8.1 **DA 2016/510 - Two-storey Dwelling - 3 Rayner Lane, Lennox Head.DOC**

**DA 2016/510 - 3 Rayner Lane, Lennox Head - Two Storey Dwelling**

8.1 **DA 2016/510 - Two-storey Dwelling - 3 Rayner Lane, Lennox Head.DOC**

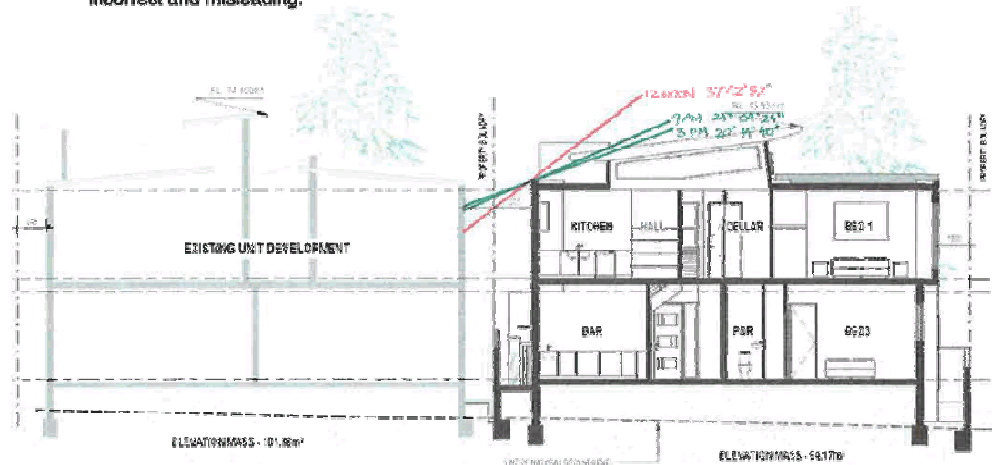
I note that the shadow diagrams provided in the application do not comply with Council's requirements for shadow diagrams at 9.00am, 12 noon and 3.00pm on 21 June and 21 December. There are no diagrams at all provided for 21 December, and the diagrams for 21 June show 9.00am, 12 noon and 3.00pm for plans, but then oddly 10.00am, 12 noon and 2.00pm for elevations.

**Section marked-up with correct 12noon sun altitude angle**

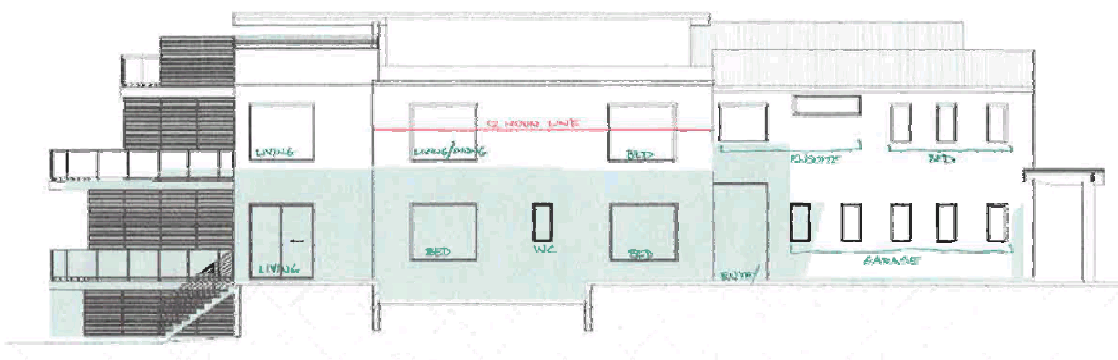
A simple check of the 21 June 12noon shadows by overlaying the correct sun altitude on the section shown on drawing DA-01-03 suggests that the shadow diagrams are somewhat incorrect and misleading:

12 Midday 21 June

**Elevation marked-up with result of correct 12noon sun altitude angle**

*(Note there is a slight difference in the angles on plan between the cut of the section and the azimuth at 12noon. On the section line the distance between buildings is 2130mm. On the azimuth line the distance between the buildings is approximately 2205mm. This has no significant effect on the simple check described above.)*

1 West Elevation  
Scale 1:100

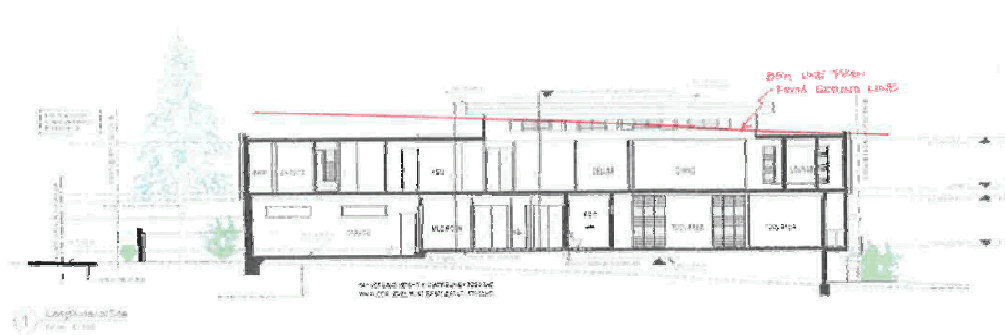
The maximum envelope above is derived from the ground level below, **NOT** an arbitrary floor level. And thus if the ground line slopes, the building envelope also slopes.

Drawing marked-up with building envelope line taken from ground line

Drawing marked-up with 8.5m line taken from ground line

Lennox Head sun angles on 21 June 2016 - Altitude

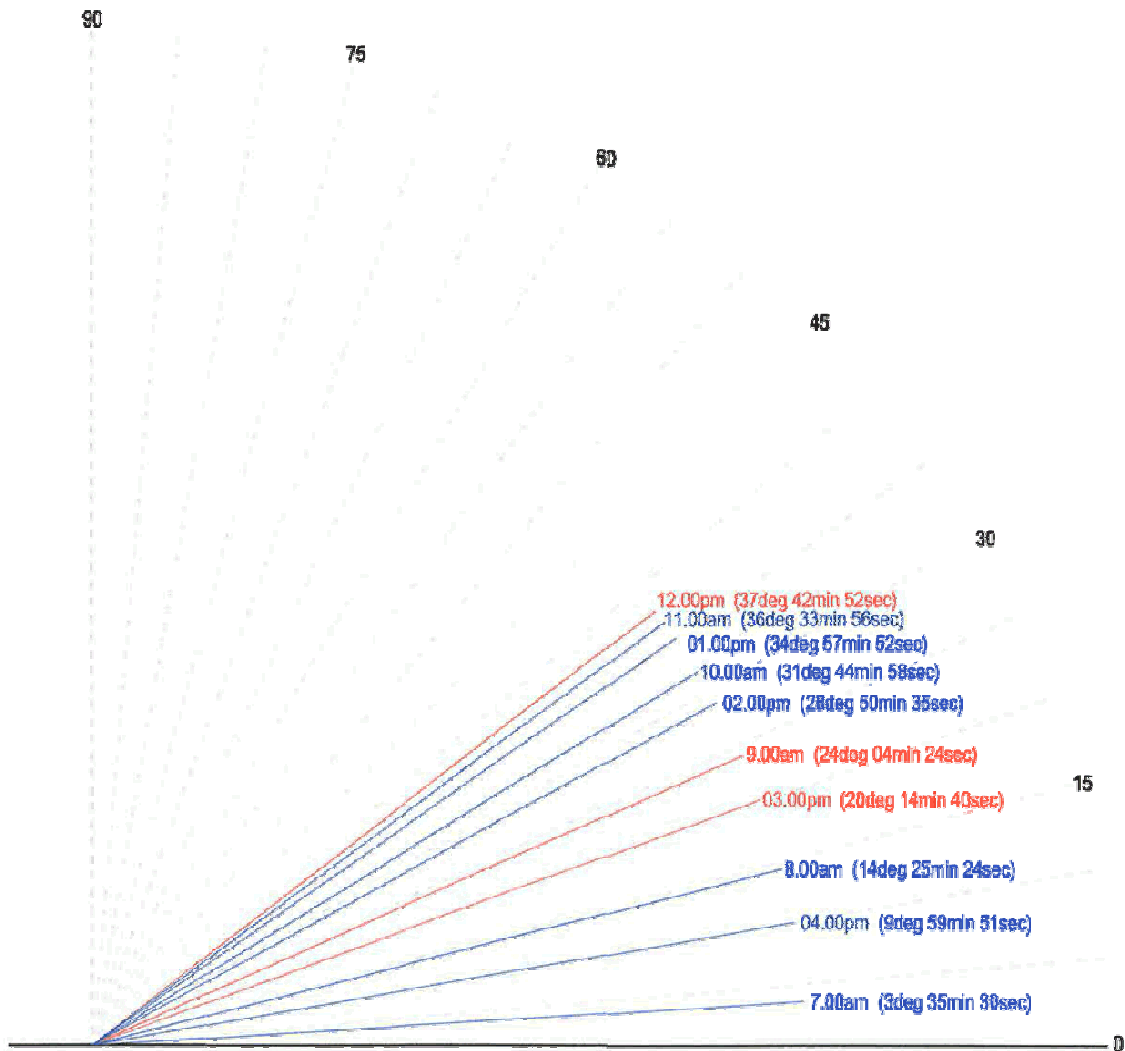
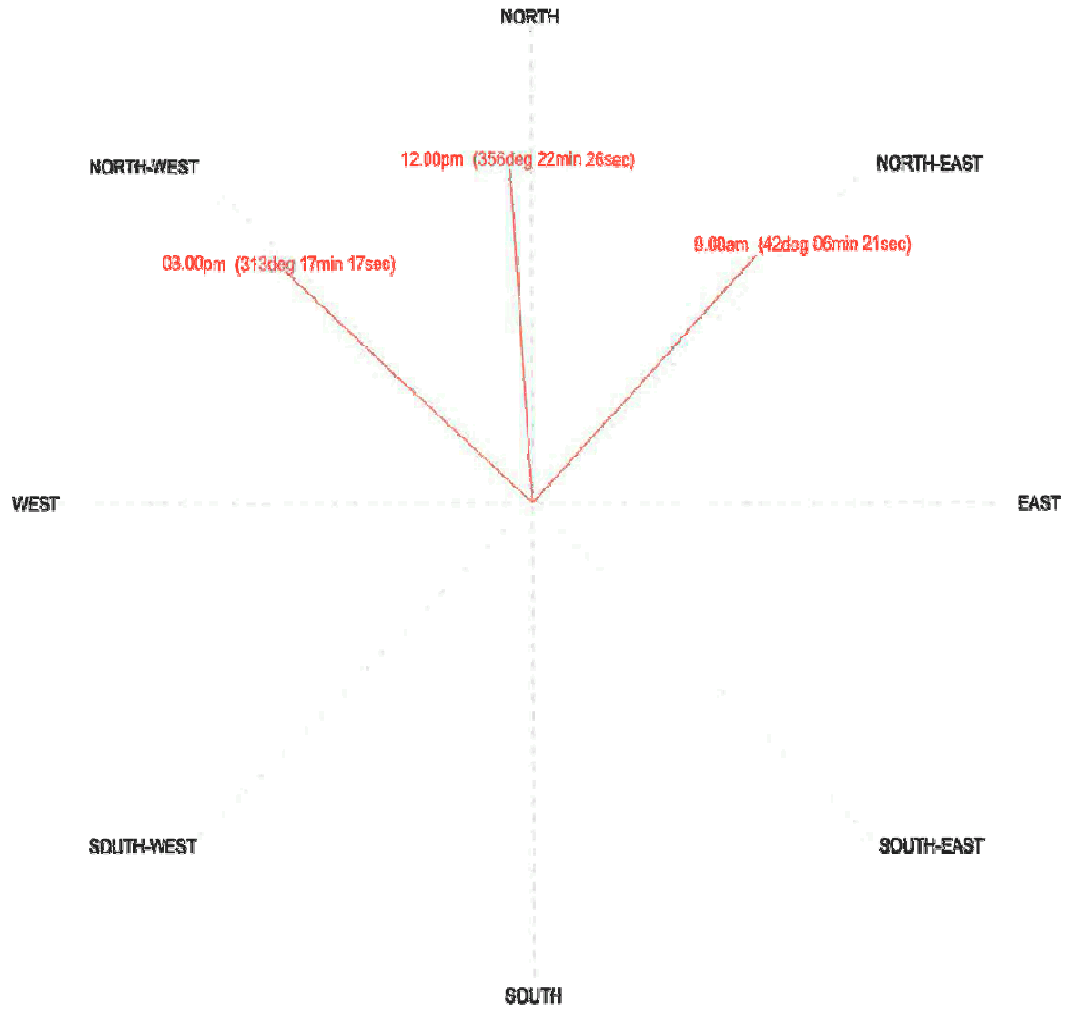
The shadow diagrams also do not state what sun angles they are based on. To fill this shortcoming I have sought the relevant information from the Australian Government, Geoscience Australia website : [www.ga.gov.au/geodesy/astro/smpos.jsp](http://www.ga.gov.au/geodesy/astro/smpos.jsp).

According to this government website the sun angles for 21 June 2016 (Australian Eastern Standard Time) were:
